| REFERENCE: | Nova Bus Manuals |
| RS N°: | MQR 7621-1881 |

| SUBJECT: | Replacement of obsolete AIC3 module by AIC4 module at +RF2. |
| JUSTIFICATION: | Obsolete AIC3 module needs to be replaced by the newer AIC4 module. |

Figure 4 - AIC3 Module Located on the Right Panel Section

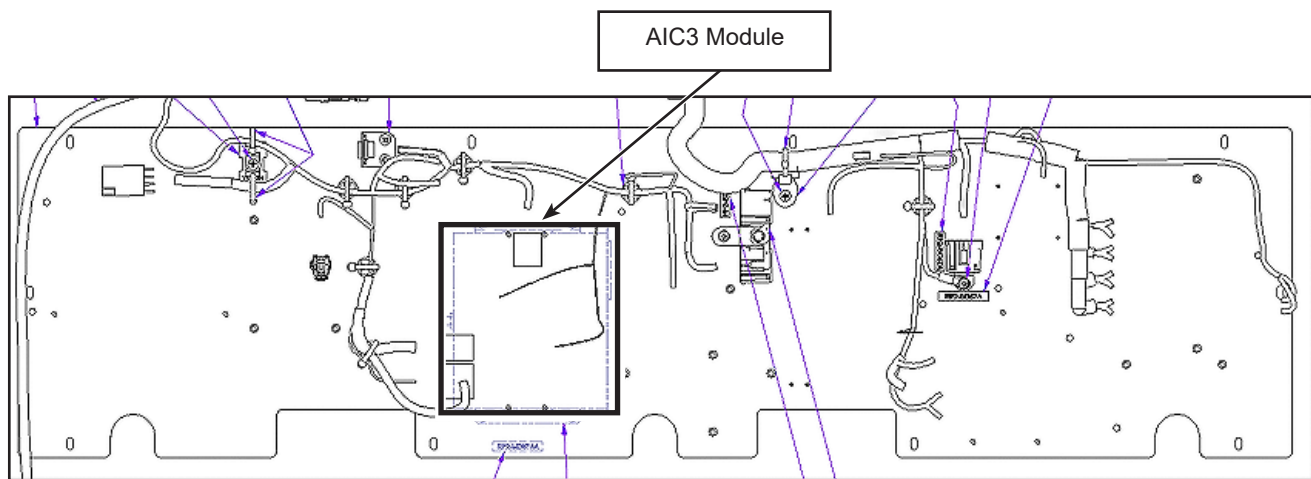
- 1.6. Locate the AIC3 module (see figure 4).
- 1.7. Disconnect the display connector and the green JAE type connectors.
- 1.8. Depending on the vehicle configuration, also disconnect the RJ-45 type connector and the Mitsumi USB type connector.
- 1.9. Remove and retain the four screws holding the AIC3 module to the +RF2 panel.
- 1.10. Remove the module from the panel.

- 1.11. Using the previously retained screws, install the AIC4 module PN N76971 at the location where AIC3 was removed.
- 1.12. Reconnect the green connectors to the AIC4 module (reconnect the RJ-45 connector if present).
- 1.13. Connect the display adapter cable PN 21816238 between the AIC4 module VGA connection and the display cable previously disconnected (see figure 5 & 6).

Figure 7 - USB Adapter Cable

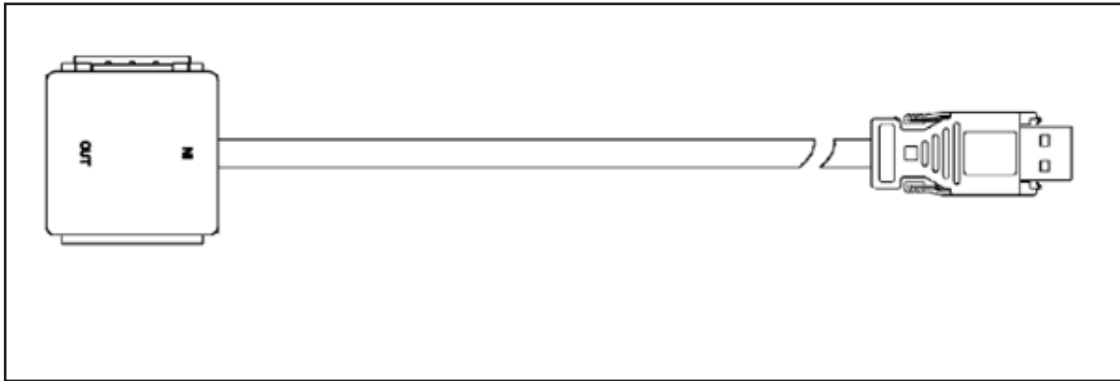
- 2.1. Connect the USB adapter cable PN 21875266 between the AIC4 module USB connection and the Mitsumi type connector previously removed (see figure 6 & 7).
